**AES Response to the Third-Party Review of the Environmental
Impact Report for the Rancho Viejo Solar Project in Santa Fe
County, New Mexico, SWCA Environmental Consultants, January
2025**

**RESPONSE TO THE THIRD-PARTY REVIEW OF THE
ENVIRONMENTAL IMPACT REPORT
FOR THE RANCHO VIEJO SOLAR PROJECT IN SANTA FE
COUNTY, NEW MEXICO,
BY GLORIETA GEOSCIENCE, A DIVISION OF
GZA GEOENVIRONMENTAL, INC.**

Figure 1.2. Project area.

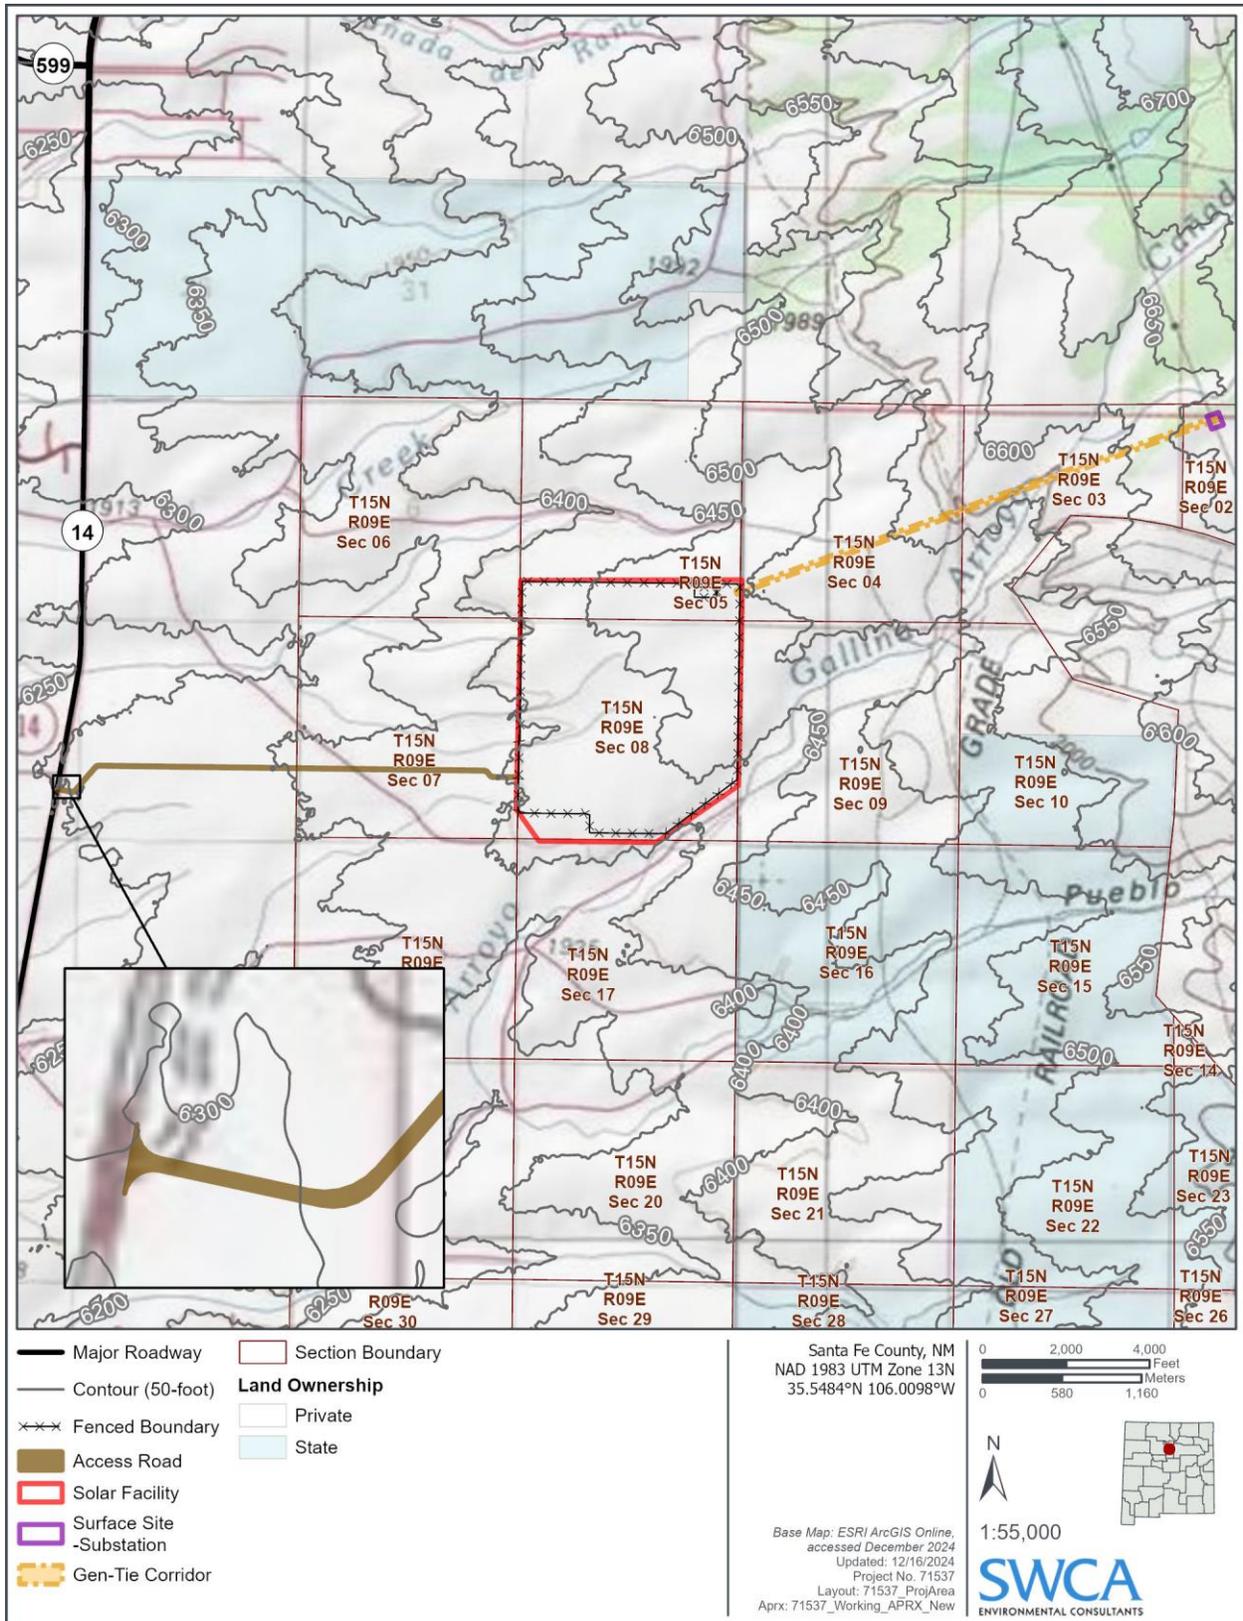
6.3.4.1.	Does the description of the project contain precise location and boundaries of the proposed development project, such location and boundaries shown on a detailed topographical map? Does the description of the project contain the location of the project on a regional map?	1-2, 1-3	No	The regional map appears to be on a topo base, but no elevations are shown/legible, and the contour lines are too difficult to see. A detailed topographic map is needed.	See Figure 1.2 (attached), which has been updated to include detailed topographic contour lines.
